RBG-45940

Subject: River Bend Station
Docket No. 50-458
License No. NPF-47
License Amendment Request (LAR) 2001-43, "High Energy Line Break
Analysis Method"

PROPOSED MARKED-UP USAR SECTIONS

FIGURE 6.2-50
 NODALIZATION DIAGRAM
 4-IN AND 6-IN RWCU LINE BREAKS
 RWCU HEAT EXCHANGE ROOM
 RIVER BEND STATION
 UPDATED SAFETY ANALYSIS REPORT

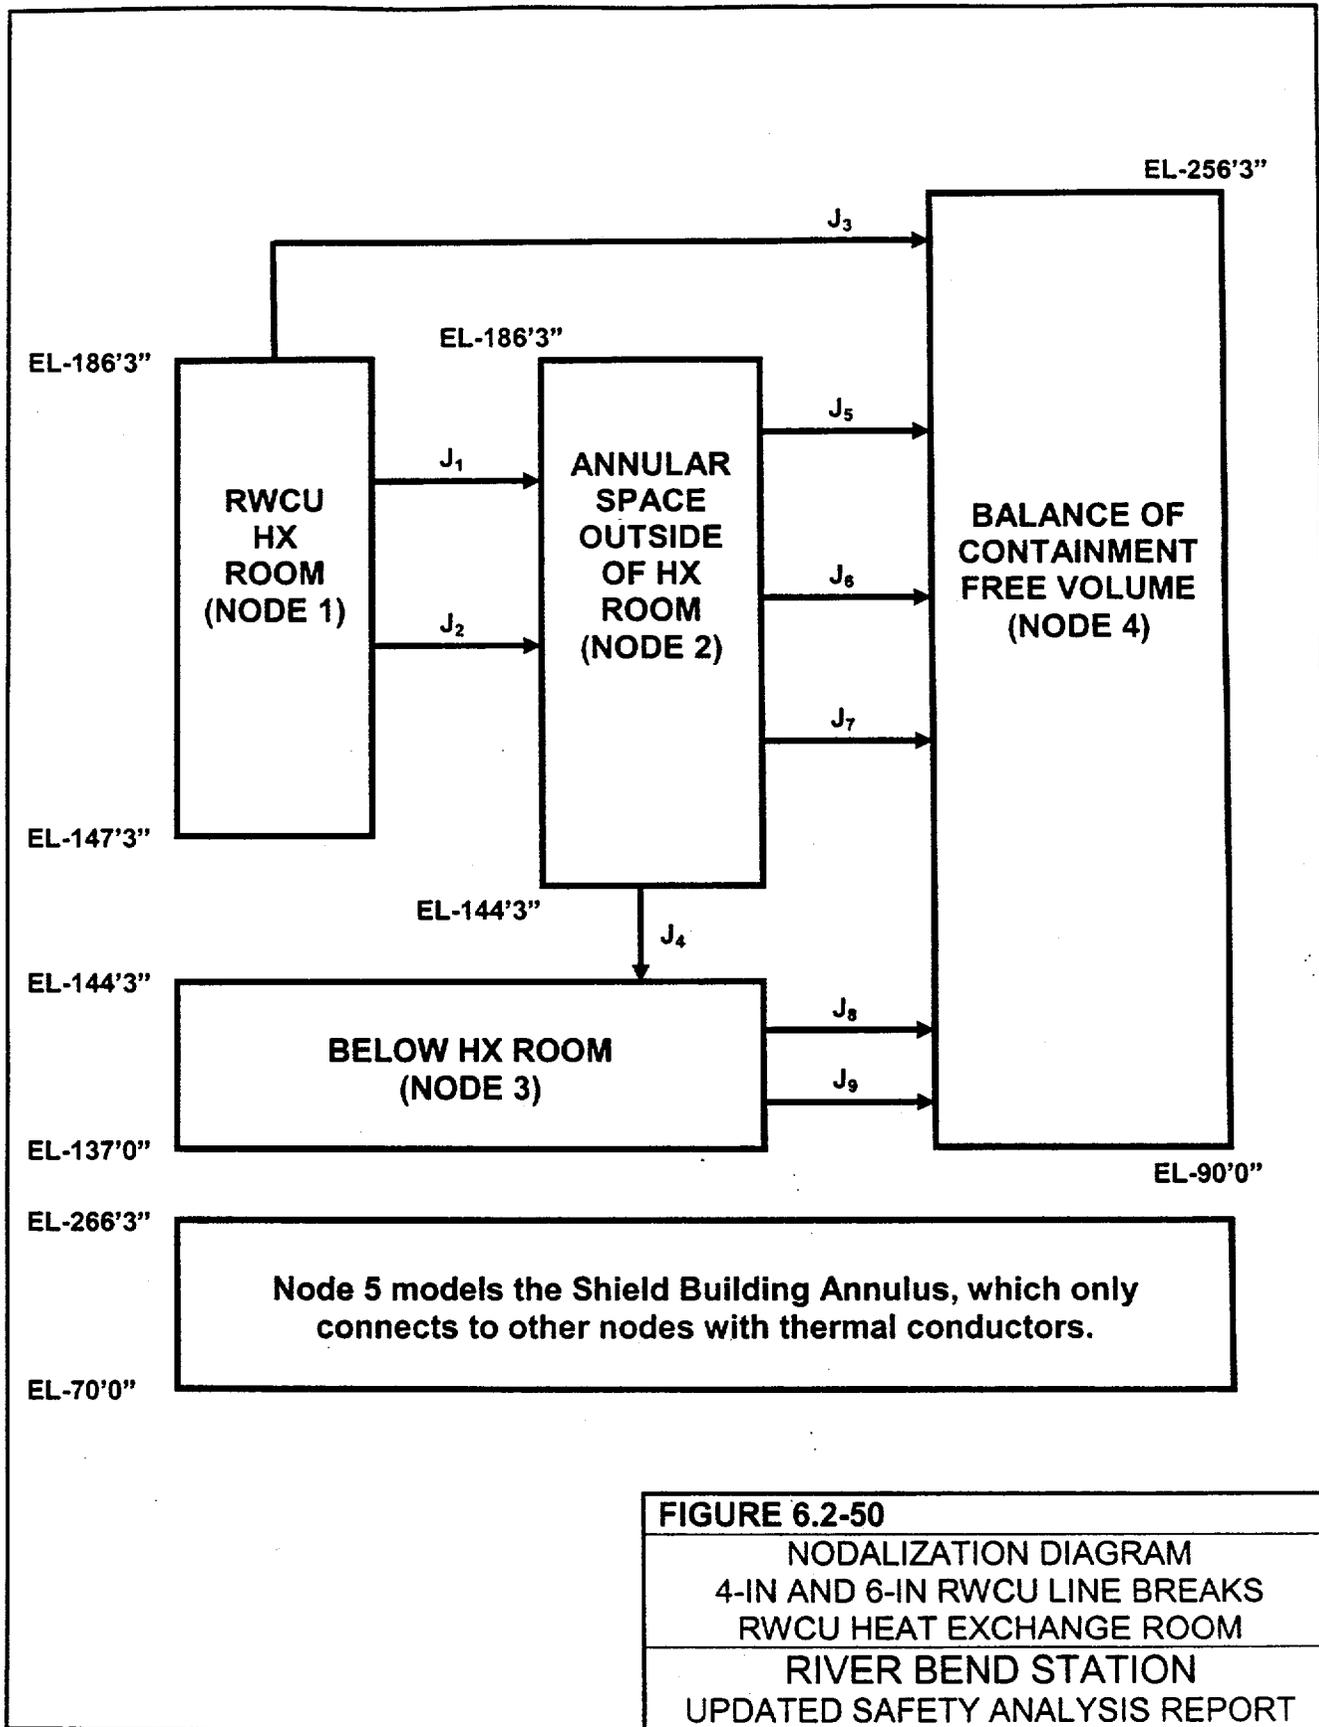
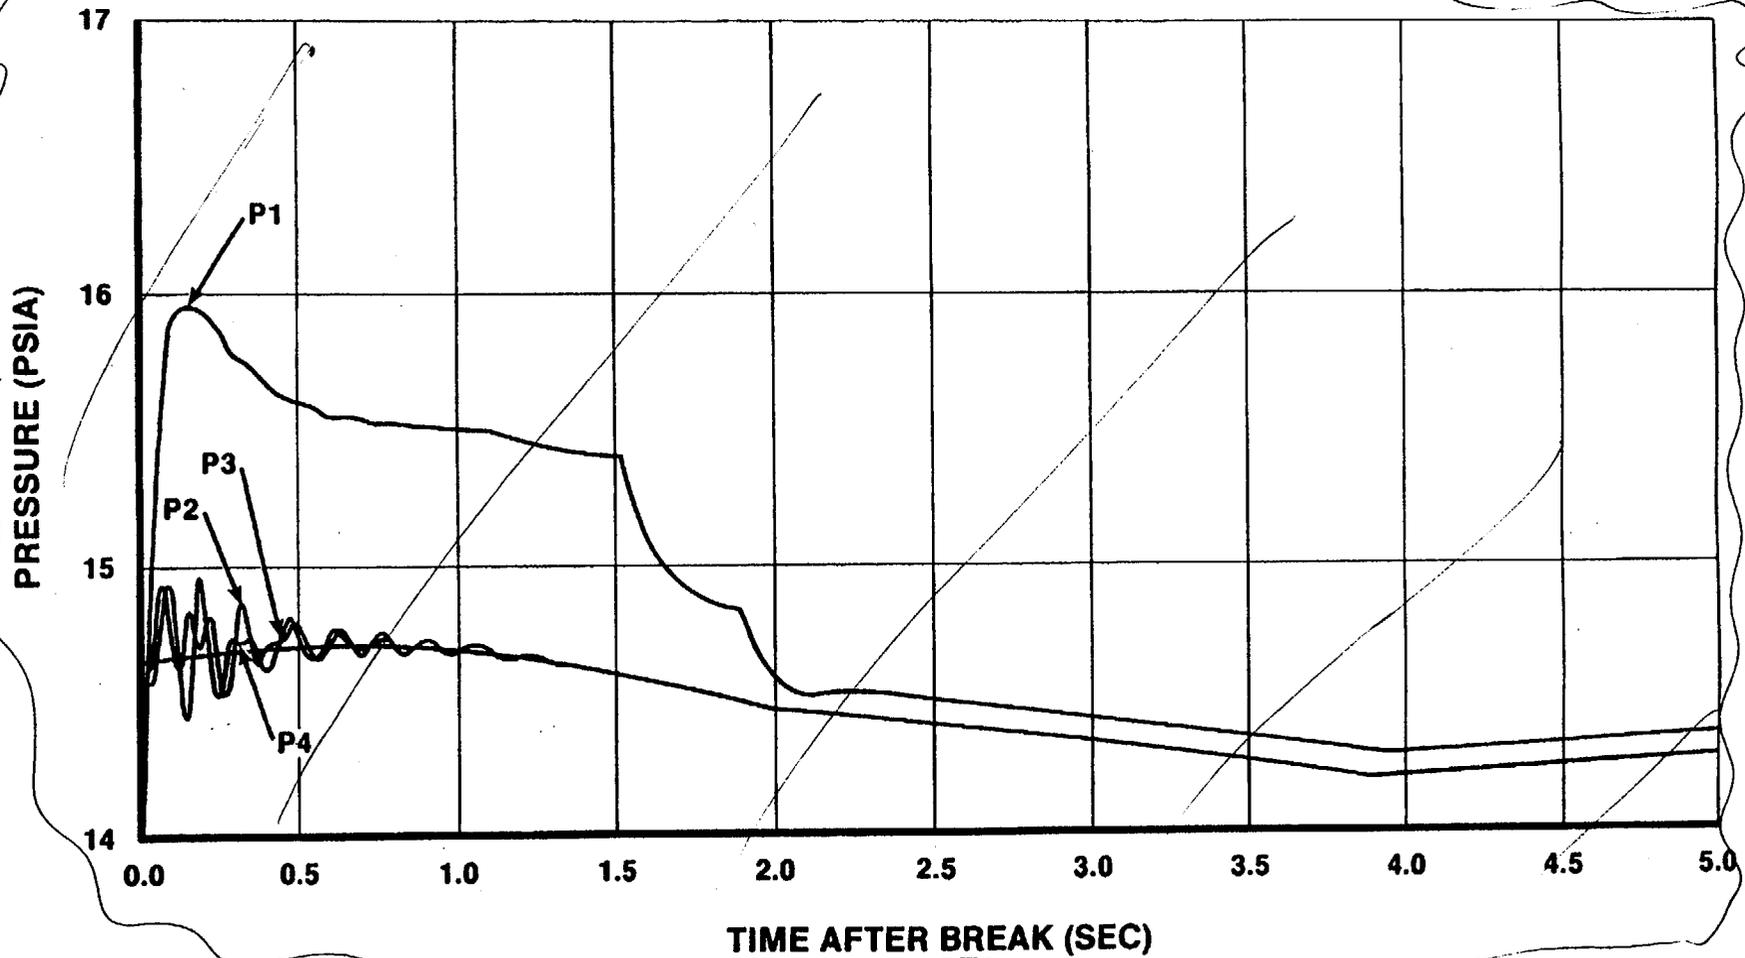
replaced with new figure

FIGURE 6.2-51

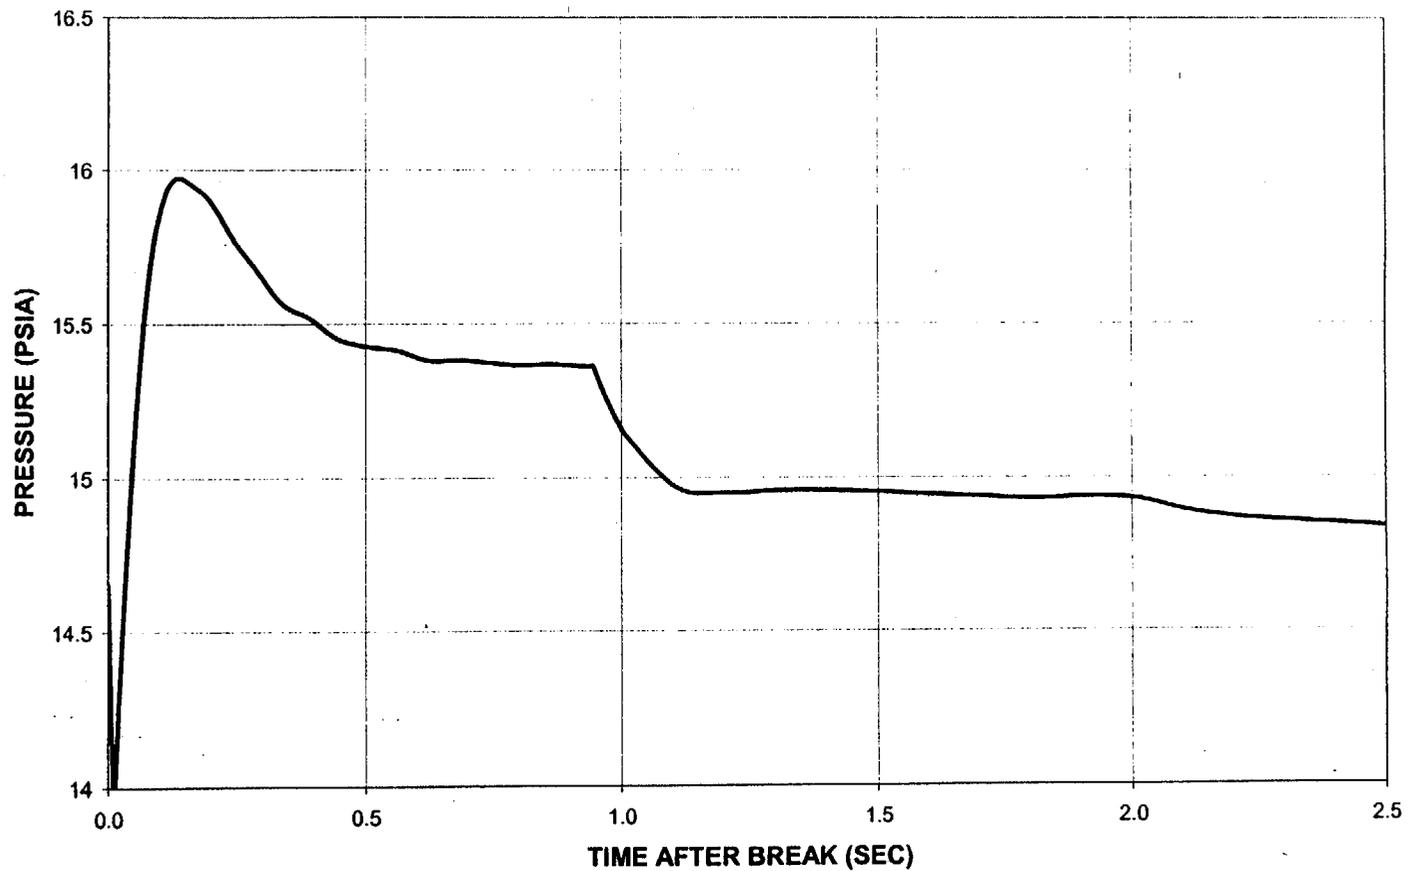
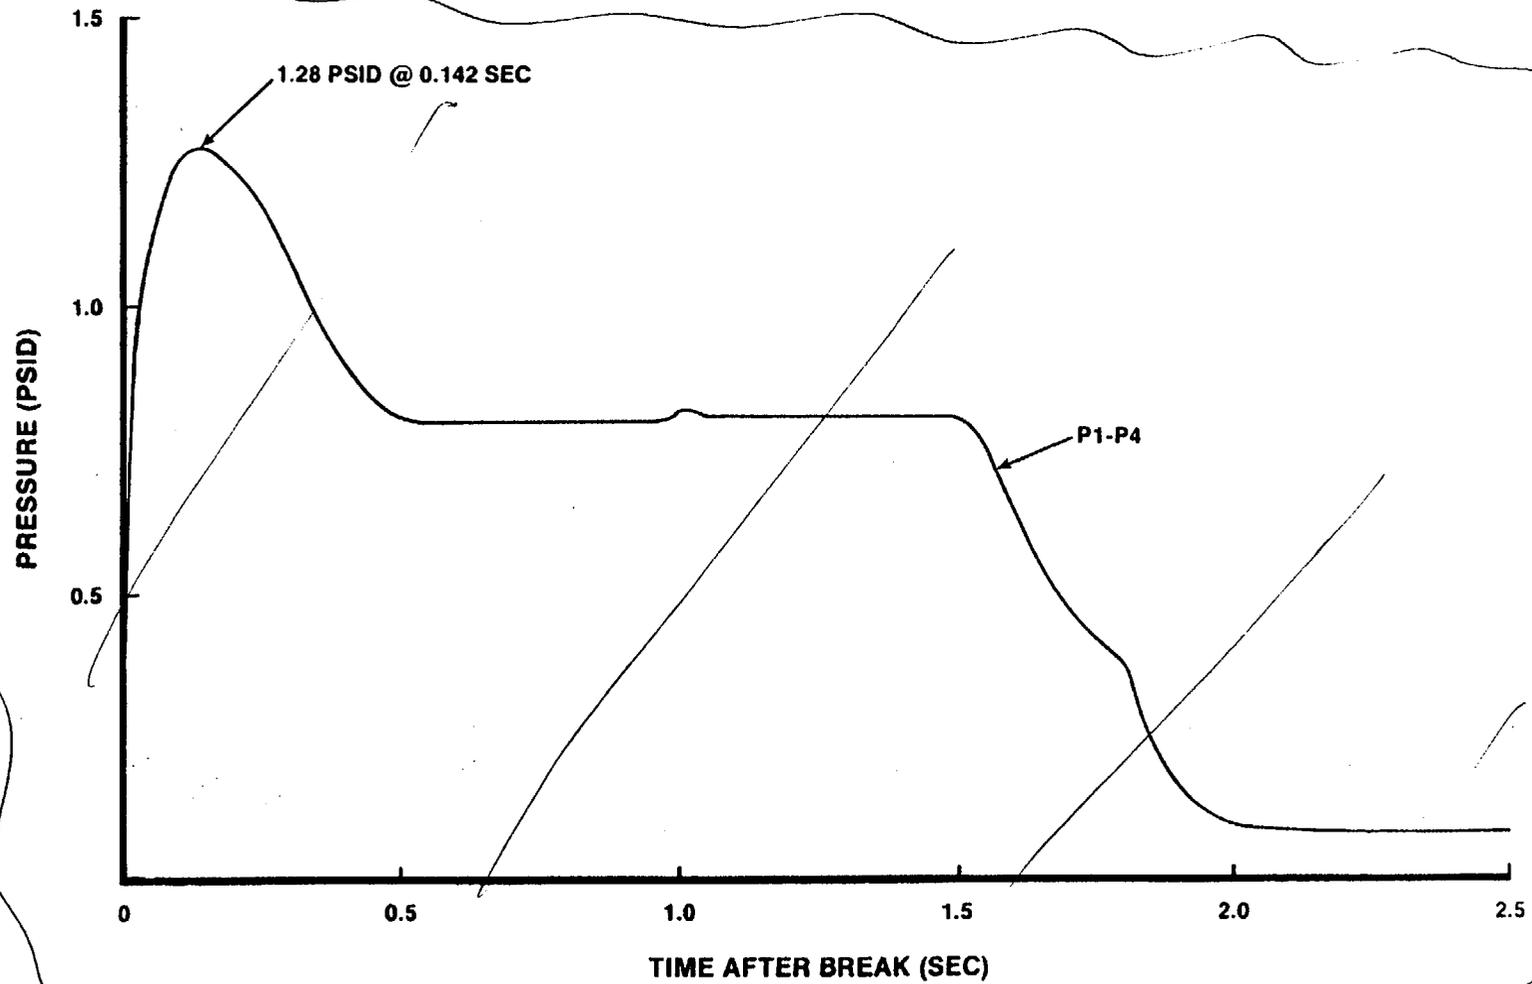
replaced with new curve

FIGURE 6.2-52

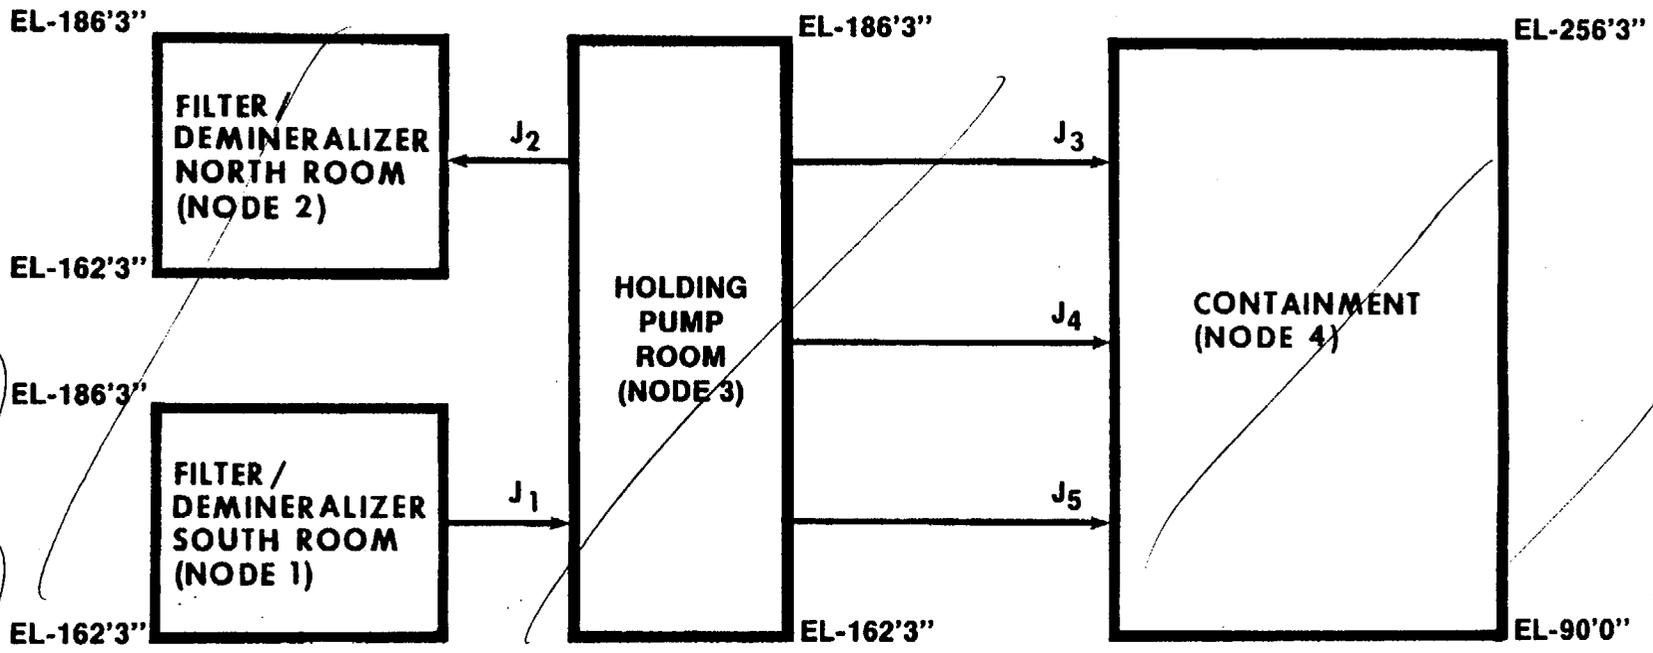
Figure deleted.
 Information has been presented in table 6.2-26.

FIGURE 6.2-53
 NODALIZATION DIAGRAM
 8-IN RWCU LINE BREAK
 RWCU FILTER / DEMINERALIZER ROOM
RIVER BEND STATION
 UPDATED SAFETY ANALYSIS REPORT

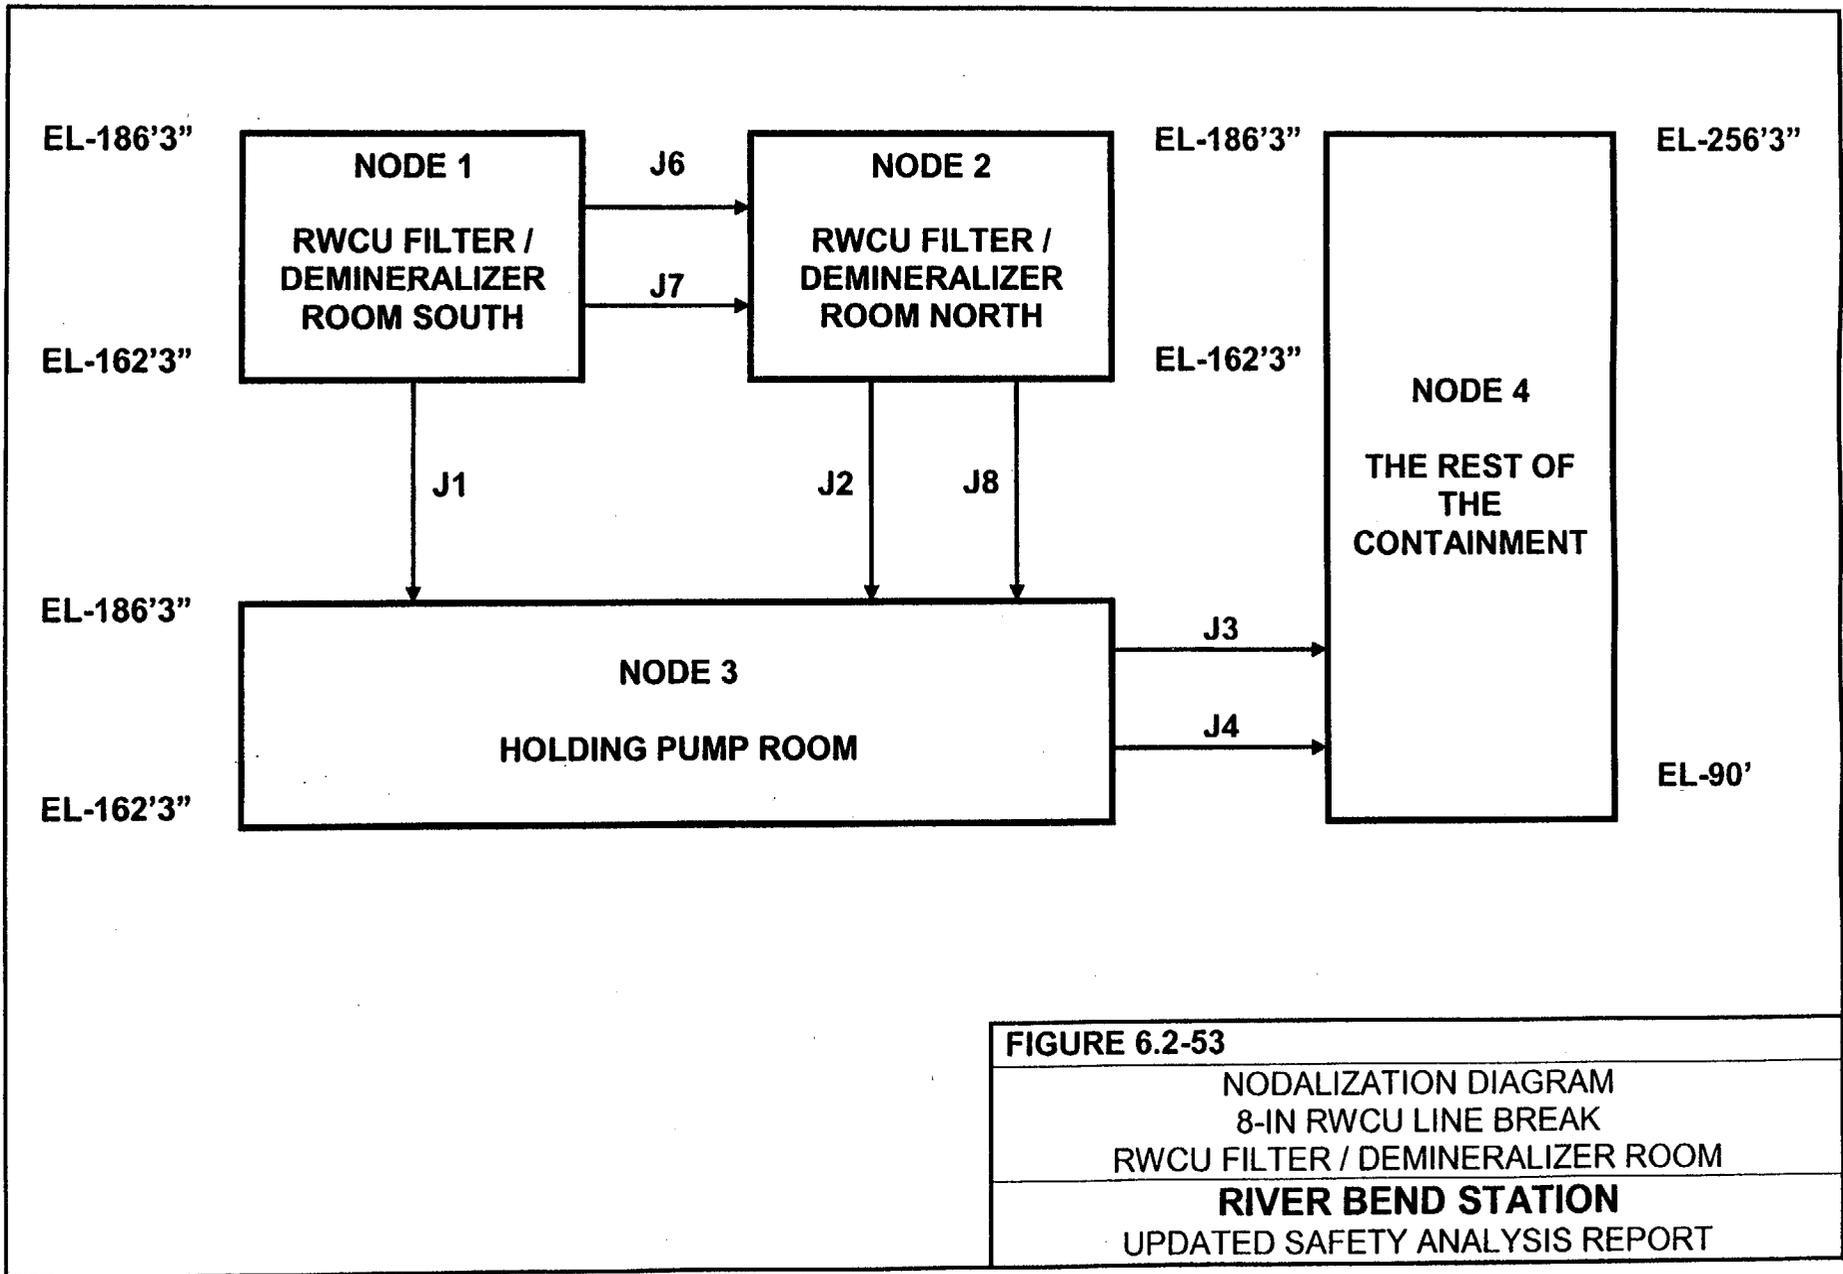
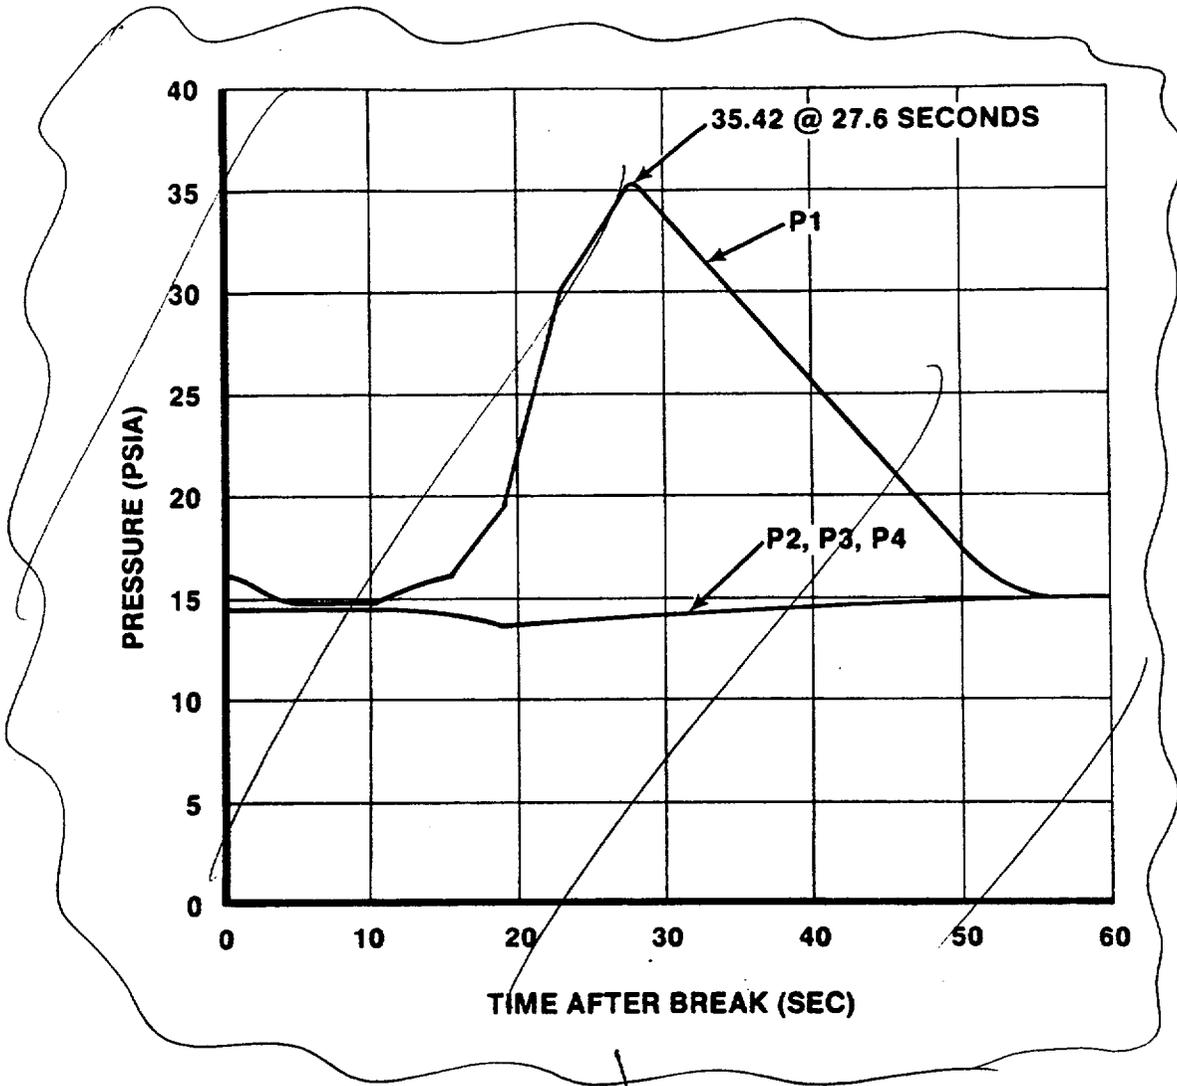
replaced by new figure.
